## Loose Steering Valve Retaining Bolts

**Product: Reelmaster® 5010 Products**

**August 7, 2014**

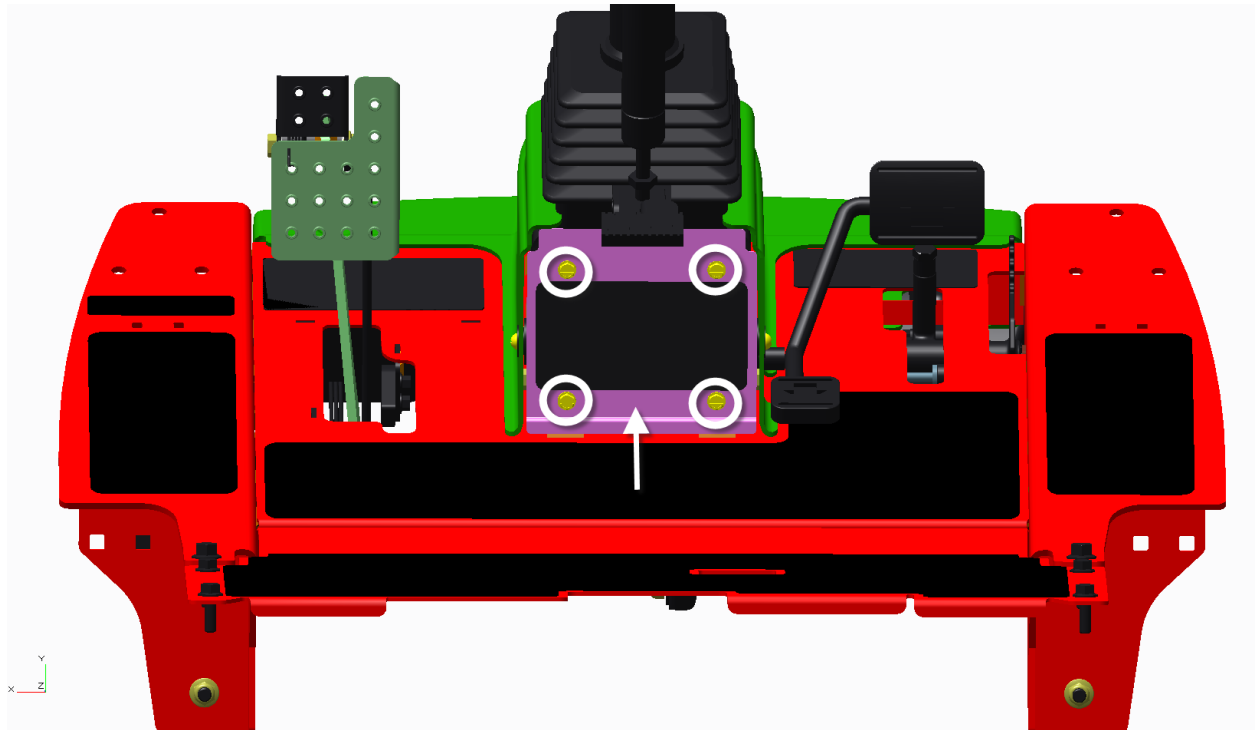
1. Remove two bolts

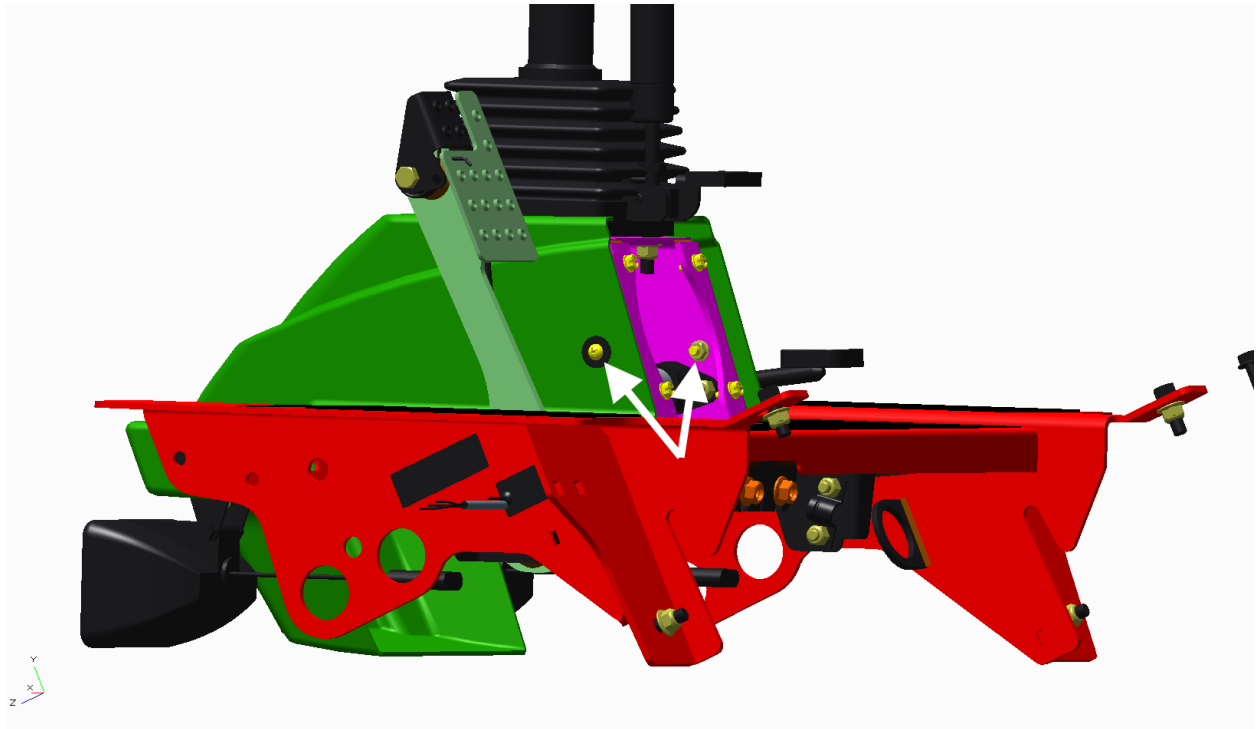
2. Remove four bolts. Remove cover

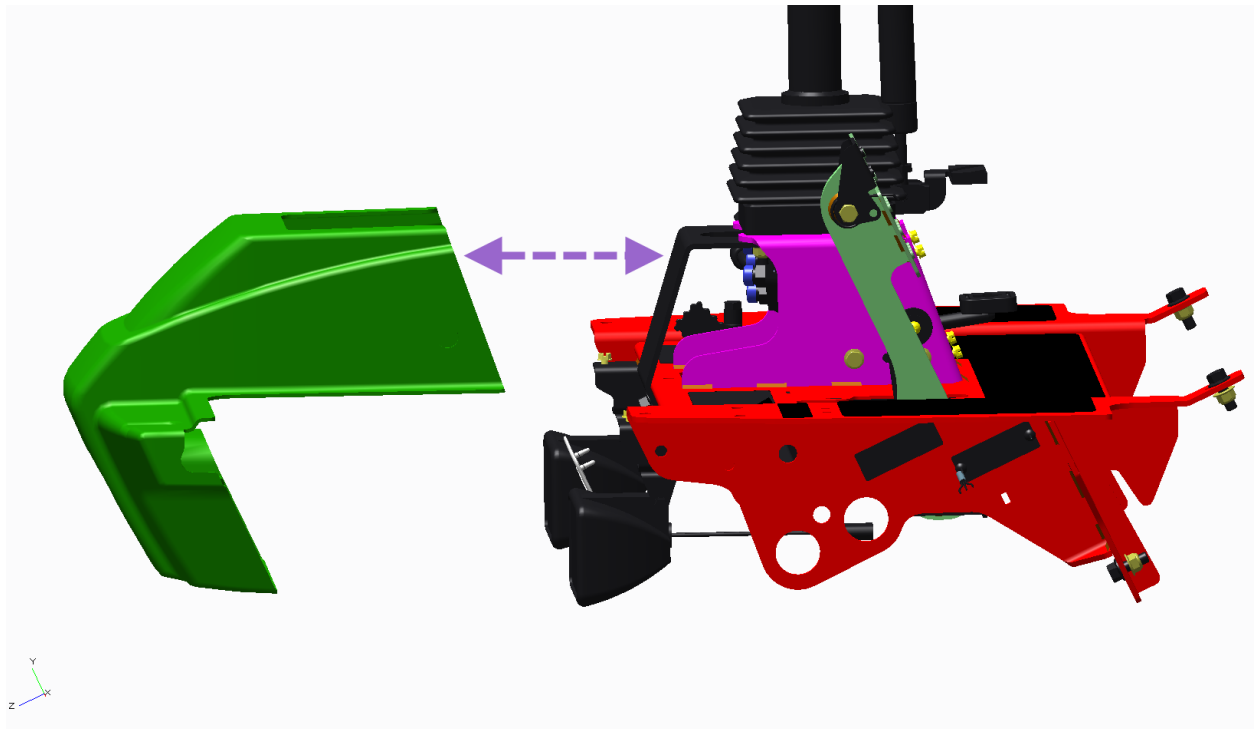
3. Remove two side bolts.

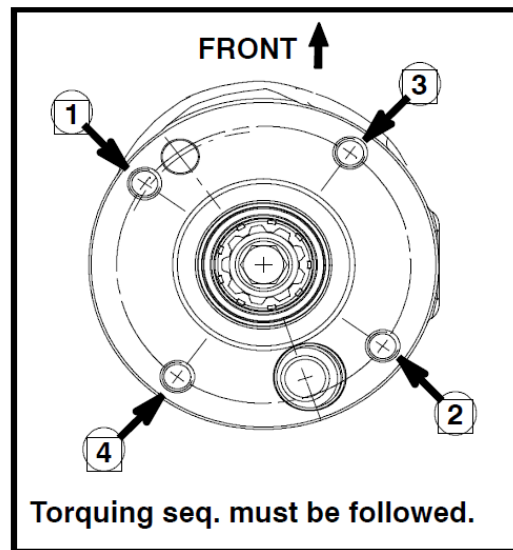
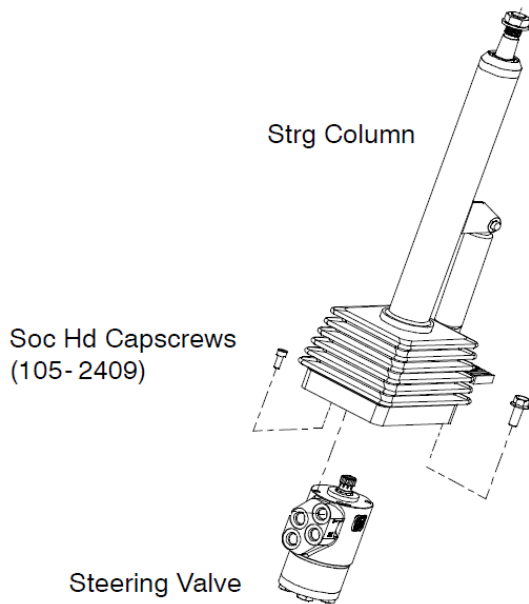
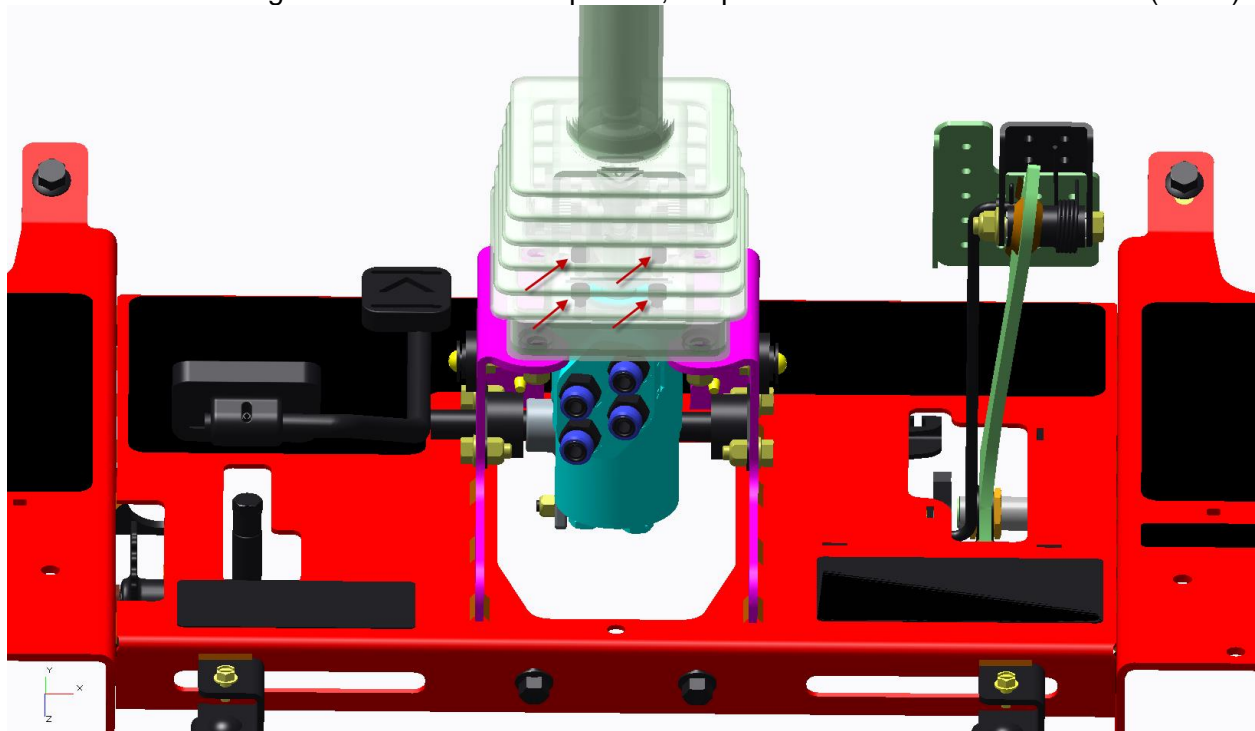
4. Remove shroud.

5. Lift rubber steering boot. In a criss cross pattern, torque four allen head bolts to 7lb\*ft (9N\*m).
